PARKWAY | VICTORIA

PARKWAY | STUDIES IN RESPONSE TO COV FEEDBACK

JULY 10, 2020

ITEMS #6 & #7 - LEVEL 1 - DP LAYOUT

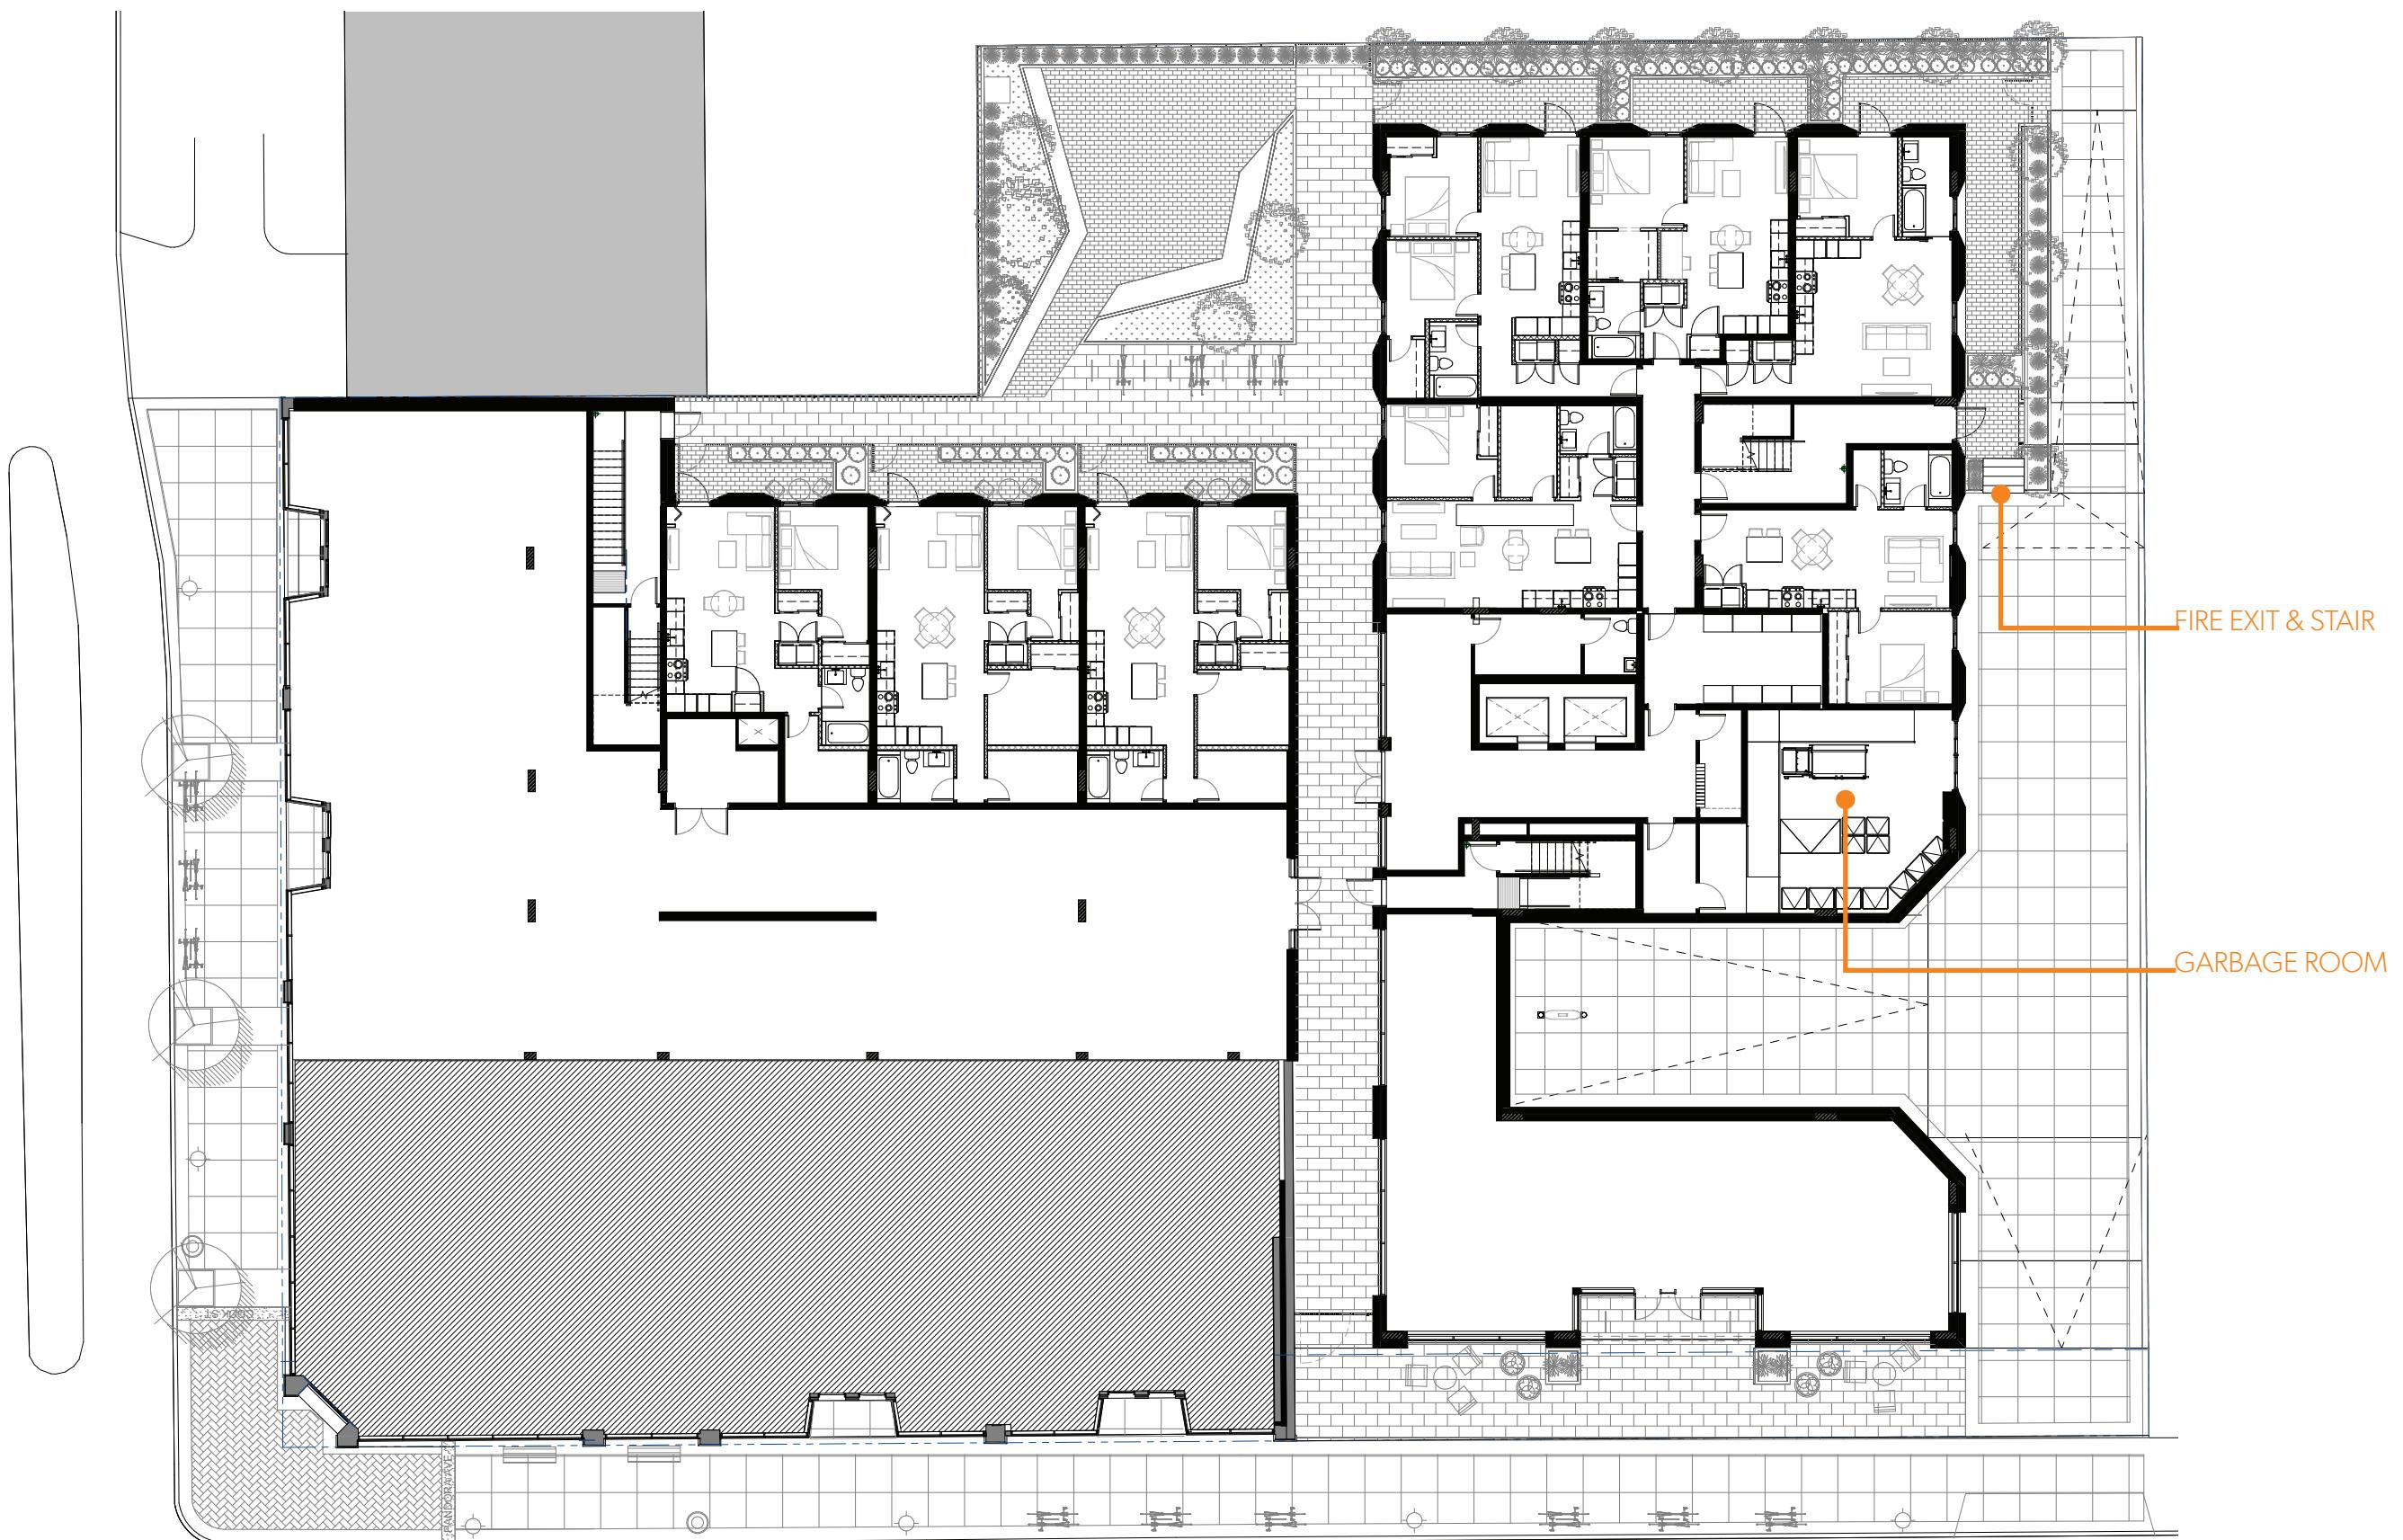
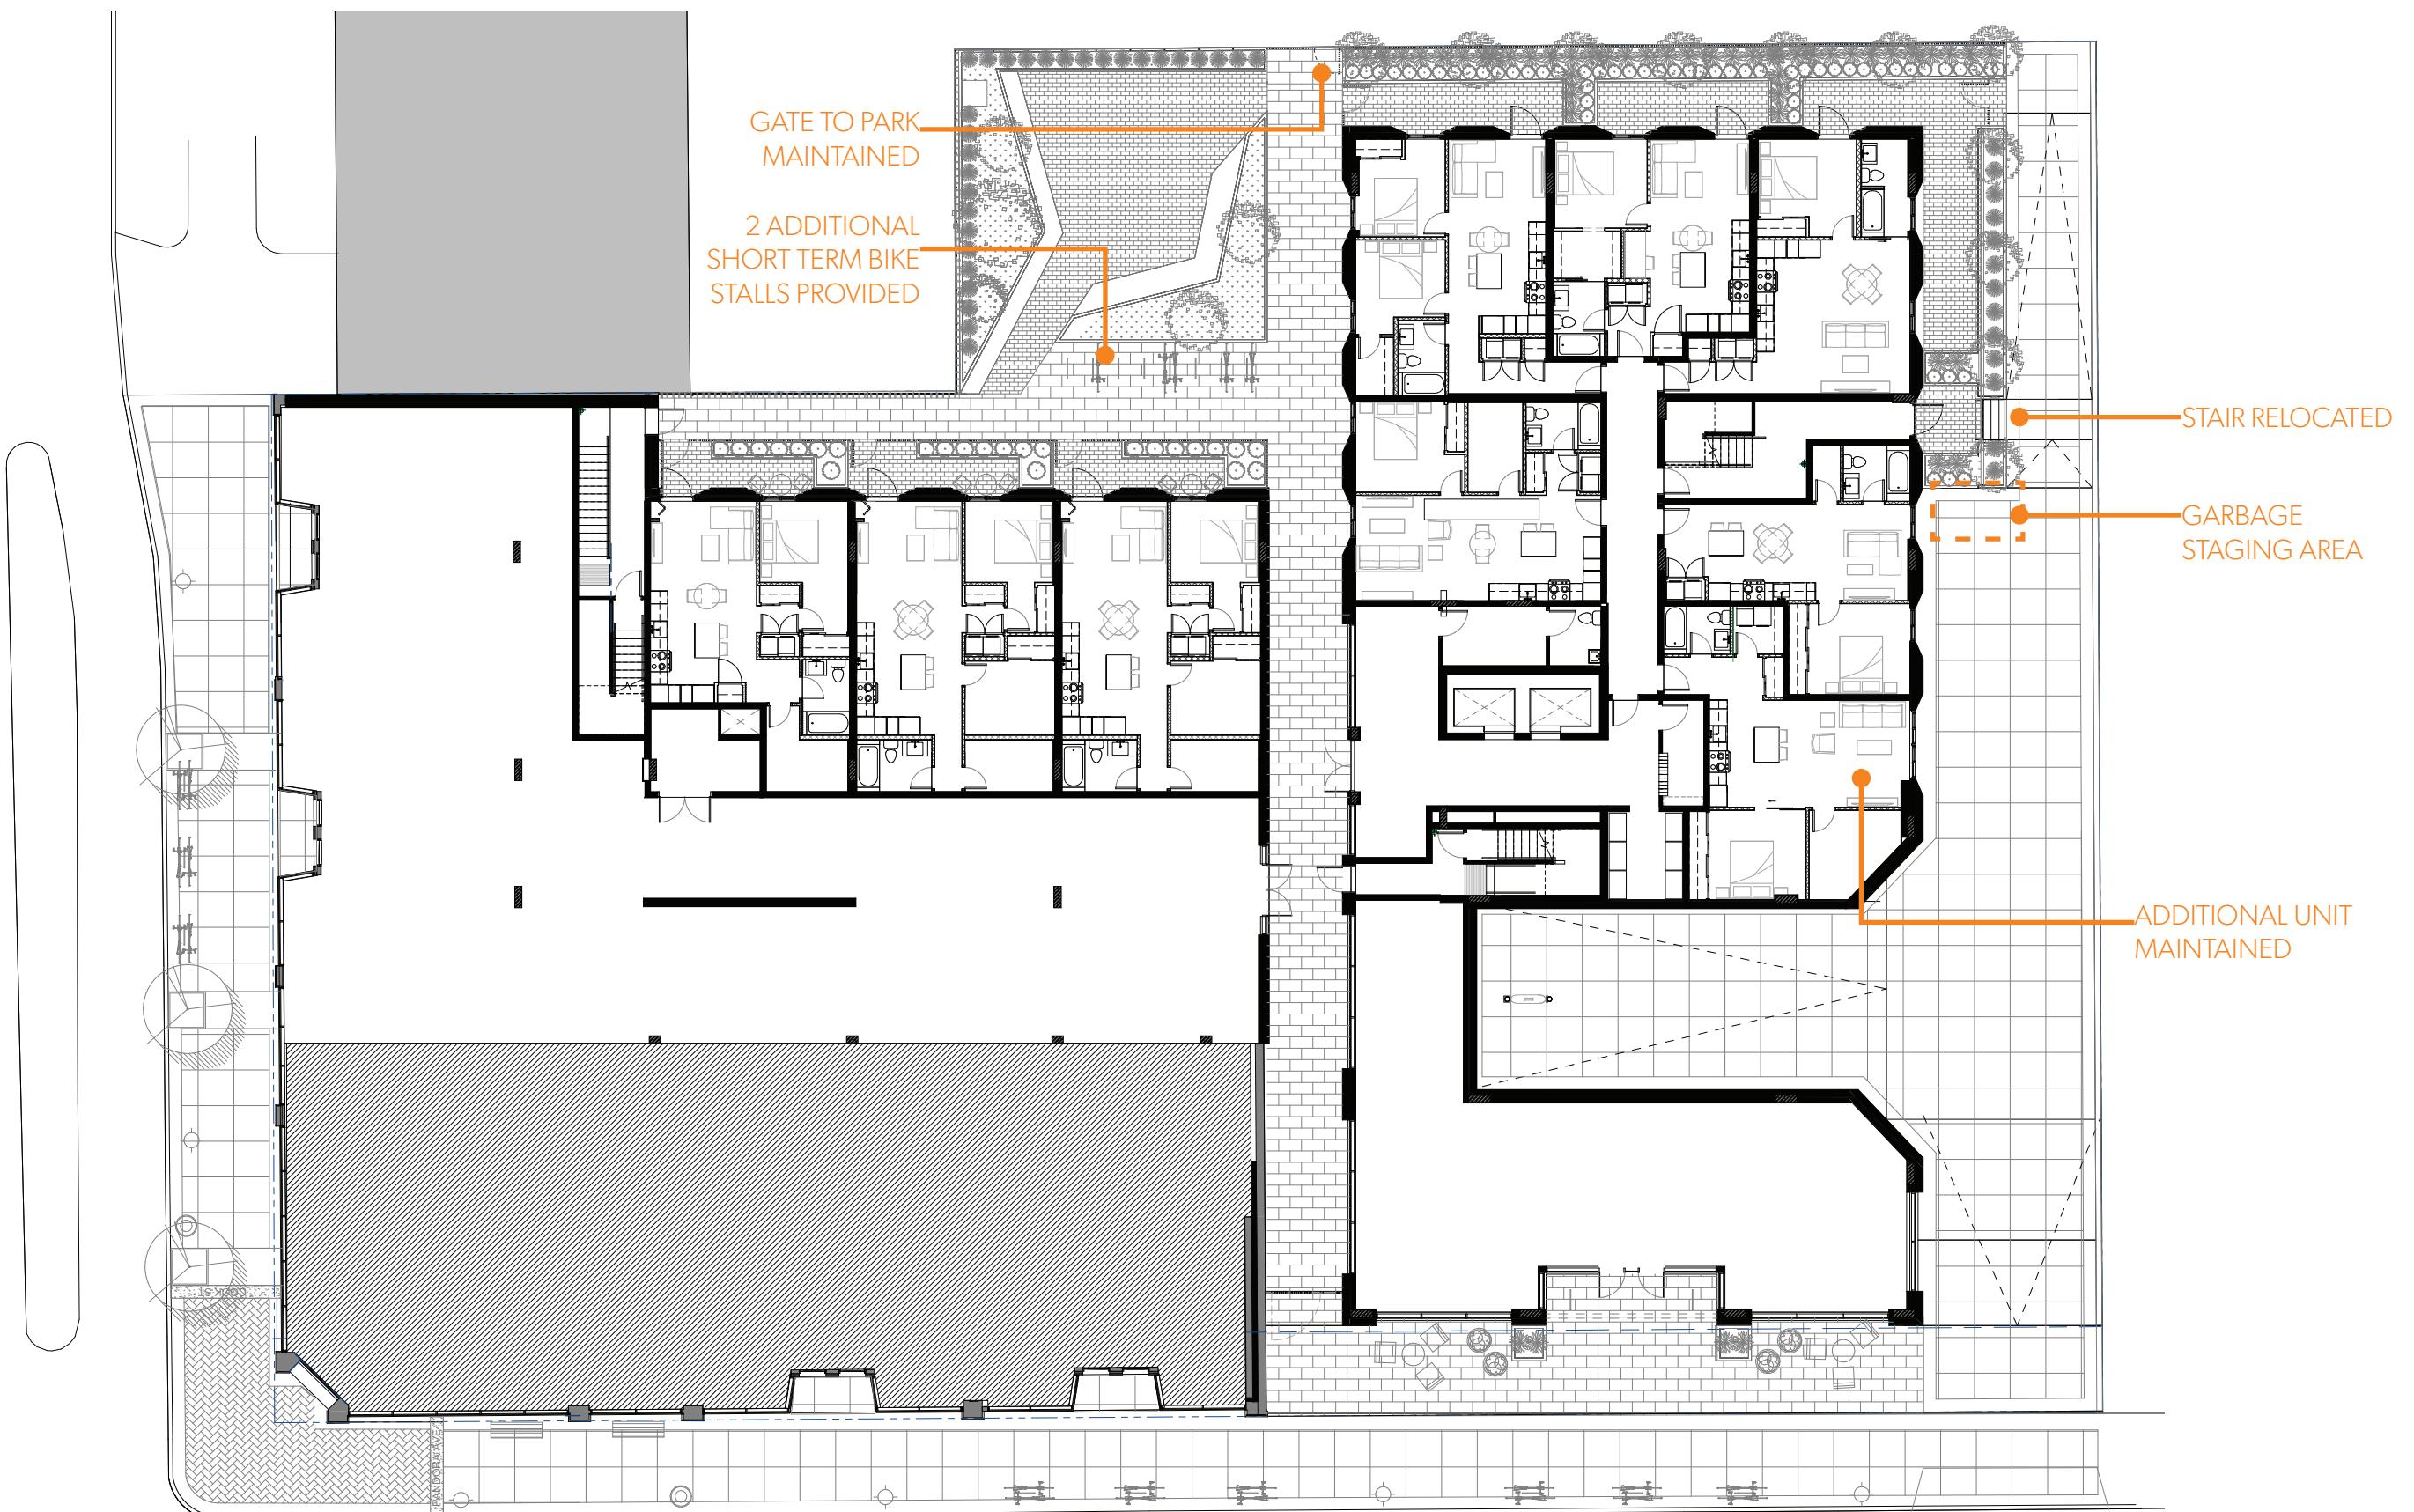
6	Level 1	Exiting	2 fire exits from the mews are required per code. Removal of gate to Franklin Green Park will result in redesign along the West Property Line and elimination of the private patios of the townhouses, loss of landscape coverage on site and loss of the 'eyes on the park'	COV to follow up with Dept. of Parks.	Awaiting response	Yes
7	Level 1	Additional unit	Relocation of garbage room to the basement level allowed for an additional unit on level 1. Additional short term bicycle stalls are added to meet bike requirements. Long term bicycle stalls remain unchanged as they are already in excess of the COV requirement	No issues. MGA to confirm FSR	FSR below maximum allowed, as per CALUC submission. Calcs will be included in Rezoning Re-submission package	N/A
8	Level 5 Roof	Sedum Roof	Design approach is maintained, except gravel roof is proposed in lieu of sedum roof, to minimize cost and maintenance.	No further questions from the City	N/A Landscape plan will be updated for Rezoning re-submission	N/A
